# Certified Action of the City of Raleigh Planning Commission

**Case File / Name:** SP-16-2010 / Golden Corral – Capital Boulevard

**Nature of Case:** The construction of a 14,107 square foot retail/eating establishment on 3.67 acres zoned Industrial-1 and Conservation Management District.

SP-16-10 Golden Corral – Site Plan

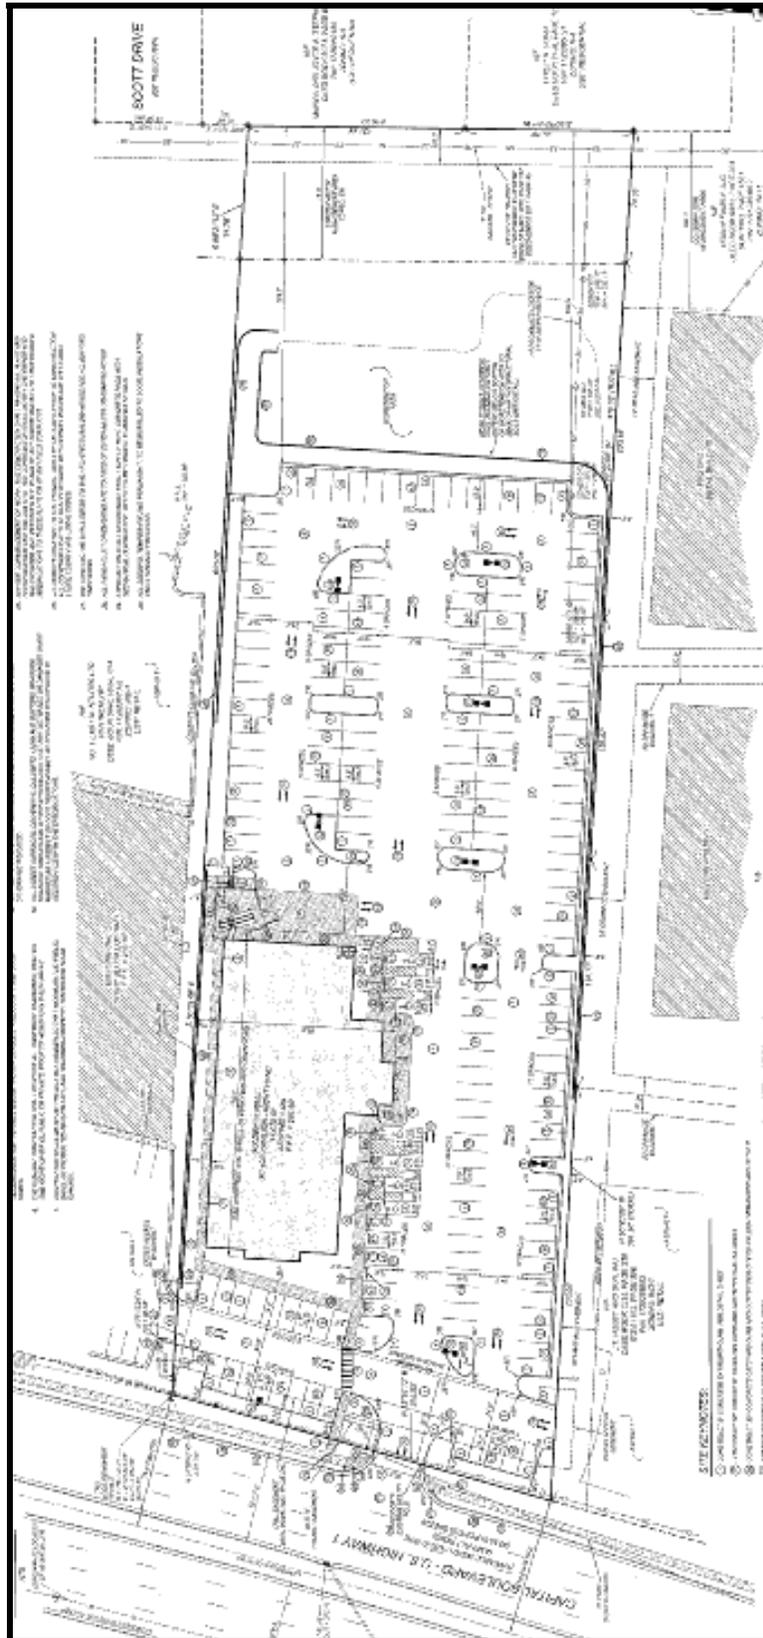
- (11) That a revised site plan showing the construction of the cross access to the property to the south is constructed to the southern property line;

<u>Comment</u>	<u>Response</u>
1. Since the northwest corner of the building will be visible to the public, the committee recommends that the masonry wainscoting treatment on the west side of the building (which will face Capital Boulevard) be continued around the north side of the building, at least as far back as the third door from the northwest corner.	2. The masonry wainscoting treatment on the west side of the building (facing Capital Boulevard) will be continued around the north side of the building as far back as the third door from the northwest corner.
